Ref: 19-0239P

RE: Response to Further Advice
1529 Creek Road, Carina – A006625093

Response to Further Advice

Table A – Changes to Youth Hall

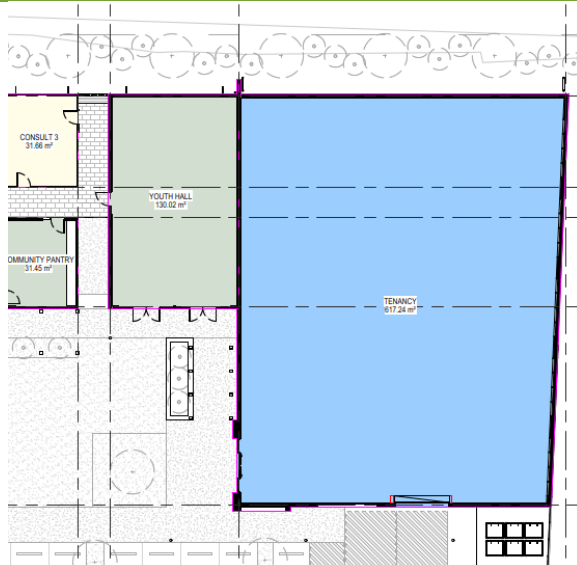
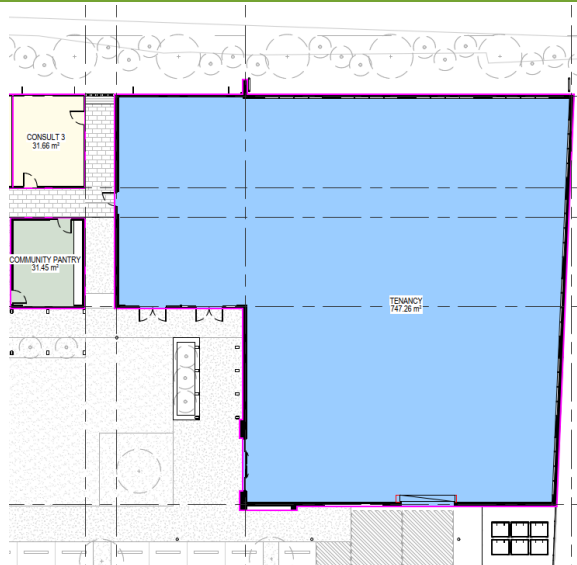
Through the applicant’s review and detailed design, a change to the Youth Hall component is sought. The proposed change seeks to subsume the Youth Hall space into the adjacent Shop use. As such, the change involves the conversion of 130m² of gross floor area (**GFA**) from Place of worship/Community use to Shop use.

The extension of the Shop use into the former Youth Hall space has not resulted in any external changes to the building façade, materiality, bulk, scale or landscaping.
